**RE: Fire Life Safety Review 1 Comment Response – Parker Pointe O’Reilly (PK2) – SP25-025.**

Please find the attached response to the Fire Life Safety first round review of the Parker Pointe O’Reilly Auto Parts Store.

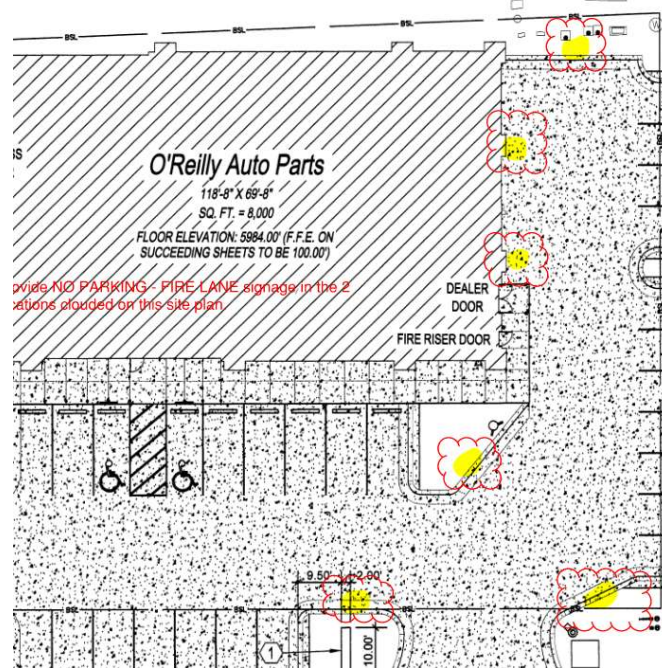
4. The fire sprinkler control valve riser room shall be provided meeting the following:
  - An exterior door shall be provided into the riser room.
  - A door, either adjacent to the riser room or a door that provides immediate access into the building through the riser room shall be provided.
  - The riser room shall be sized such that a three-foot clear space is provided around the sprinkler riser with the Fire Alarm Control Panel being located on an interior wall. A three-foot clear space is required in front of the FACP. A minimum of 18" is required behind the riser as well as to each side of the riser.

- A sidewalk is required to be provided from the drive aisle to the riser room.
- A 5' x 5' concrete pad shall be provided in front of the FDC with a sidewalk provided to the FDC.
- A detail (floor plan) of the riser room is required to show how the room is to be laid out (arranged), that all clearances are met, and that exterior access has been provided into the riser room with the required access into the building. This is a requirement and will not be allowed to be deferred.
- Address any other equipment utilities that may be anticipated to be located in this room; clearances for fire suppression and the FACP are not allowed to be encroached upon.

- Exterior door is provided.
- An exterior door is directly connected to the fire riser room.
- Refer to Sheet FP1 for fire riser detail (“Named 02 Prelim. Fire Protection Plan - Parker Pointe Auto Parts Store”)
- Sidewalk provided from fire riser door to drive aisle.
- 5’x5’ pad provided in front of FDC.
- Refer to Sheet FP1 for fire riser detail (“Named 02 Prelim. Fire Protection Plan - Parker Pointe Auto Parts Store”)
